FINAL PLAT HAWTHORNE THIRD ADDITION

RE: SUB 2004-33 -- Final Plat of Hawthorne Third Addition

At the regular meeting of the Subdivision Committee of the Metropolitan Area Planning Commission on Thursday, May 13, 2004, the above captioned plat was considered. The action of the Committee was to approve the final plat, subject to the following staff comments:

CASE NUMBER: SUB 2004-33 -- HAWTHORNE THIRD ADDITION

FINAL PLAT

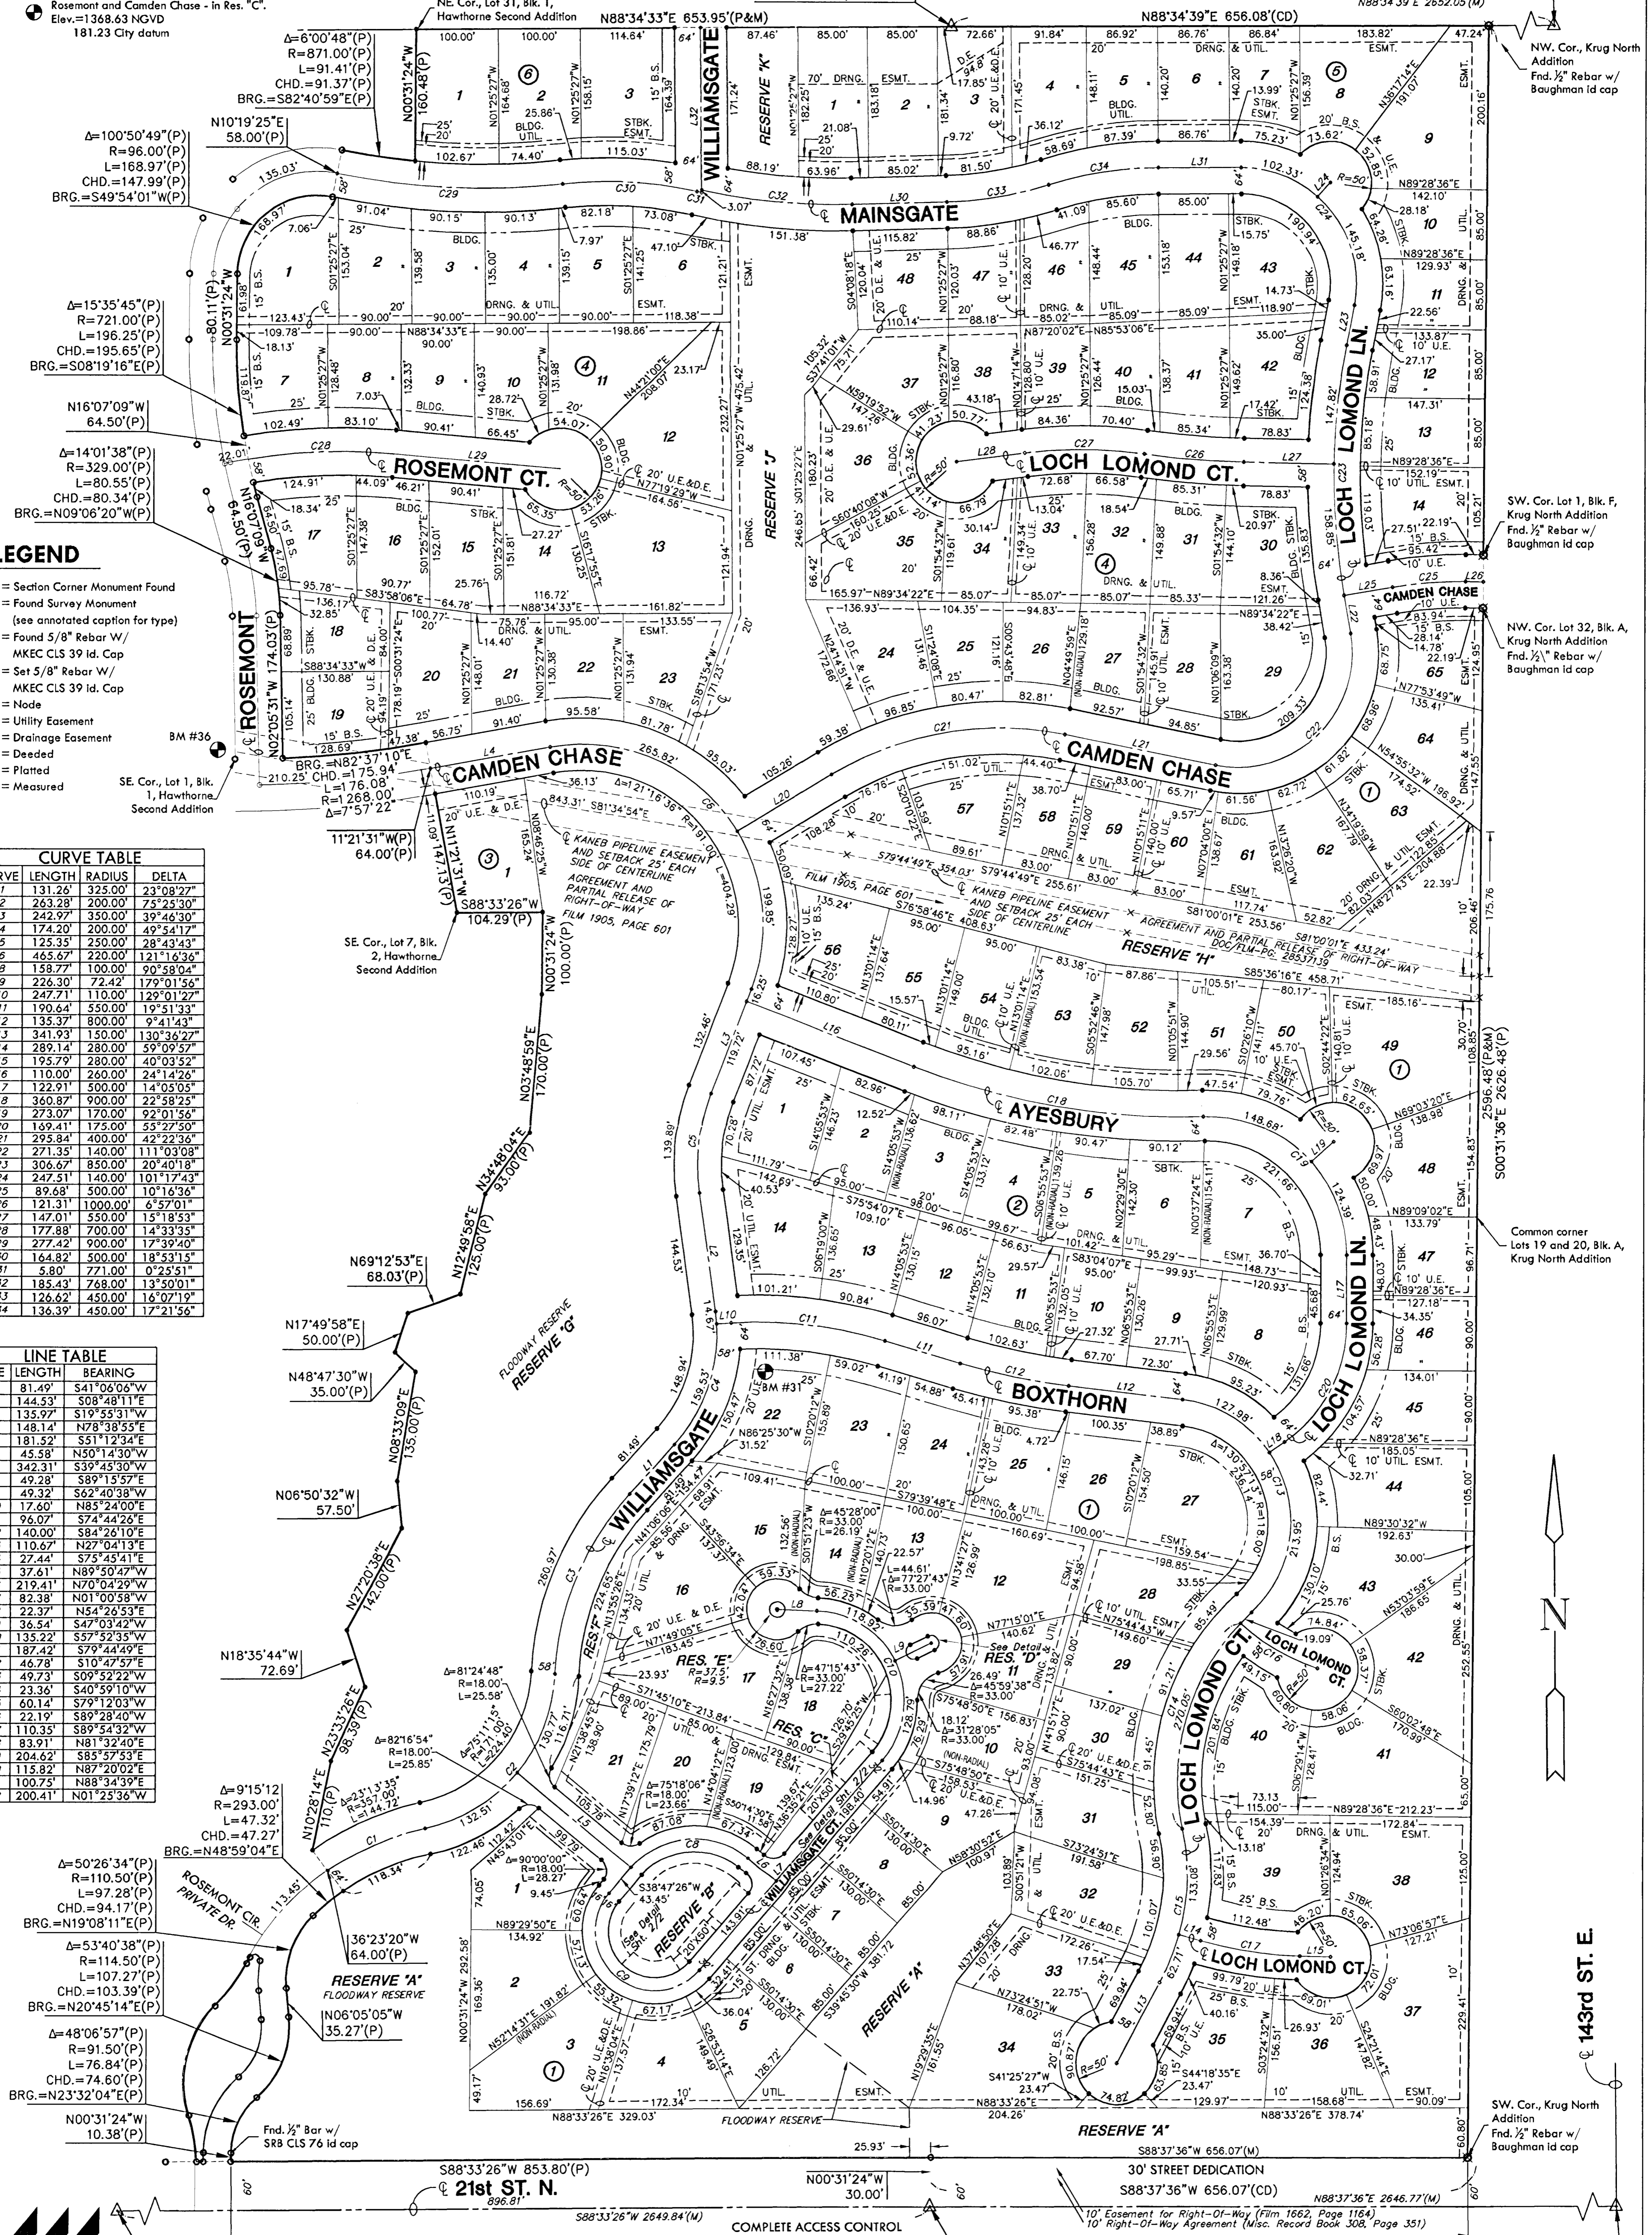
- F. The parking easements need to be labeled. Their reference in the plat's text as being "hereby granted to the public" needs to be deleted.
- G. Enlargements of various "Details" indicated on the plat need to be included.

- H. Williamsgate Ct has been platted as a 32-ft narrow local residential street. A 15-ft street drainage and utility easement is needed along the street.

- O. *GIS* needs to comment on the plat's street names. *The street stub extending to the east - Camden Chase - needs to be labeled.*
- P. The signature line for the City Clerk needs to be revised to reference "Karen Sublett".

- R. The legal description needs to be revised to clarify "Part of Williamsgate, Camden Chase, and Mainsgate".
- S. The platting text shall include language that a drainage plan has been developed for the plat and that all drainage easements, rights-of-way, or reserves shall remain at established grades or as modified with the approval of the applicable City or County Engineer, and unobstructed to allow for the conveyance of stormwater.

- AA. The representatives from the utility companies should be prepared to comment on the need for any additional utility easements to be platted on this property. **Westar Energy and SBC have requested additional easements.**
